July 31, 2024

ADDENDUM 1

RE: **IM 0907(93)310, Aurora County – PCN 09P1**
Road Closure Gates on I90 at Exit 310 (US281)

OVERVIEW I90 & US HWY 281

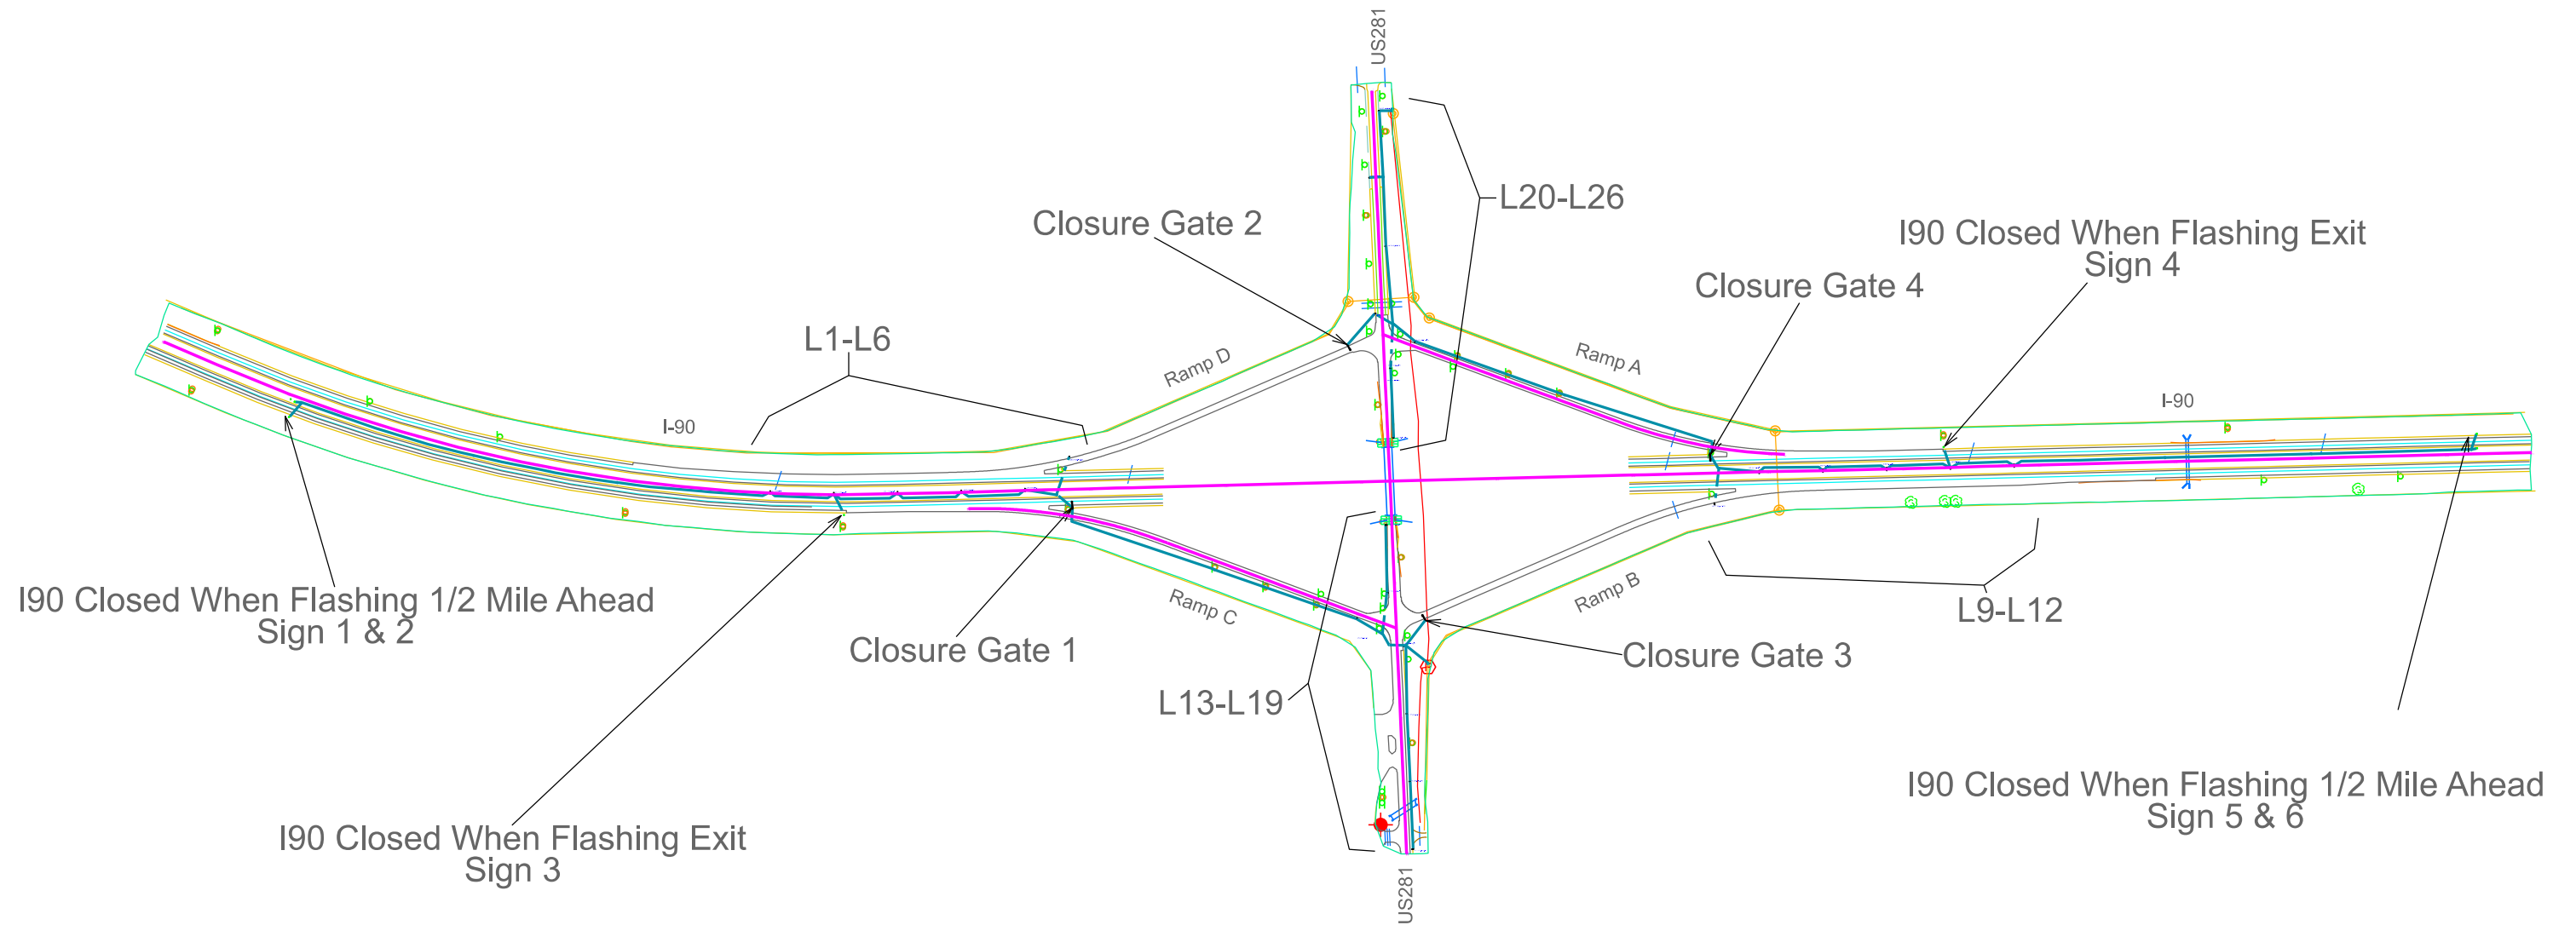
20	Changes to plan Overview	7-24-2024 - RR
21	Revised EOQ table	7-24-2024 - RR
22-30, 32-37, 39-40, 42	Changes to wire call outs, change of pole name labels	7-24-2024 - RR
43-44	Removal of poles from wiring diagrams, change of pole name labels	7-24-2024 - RR
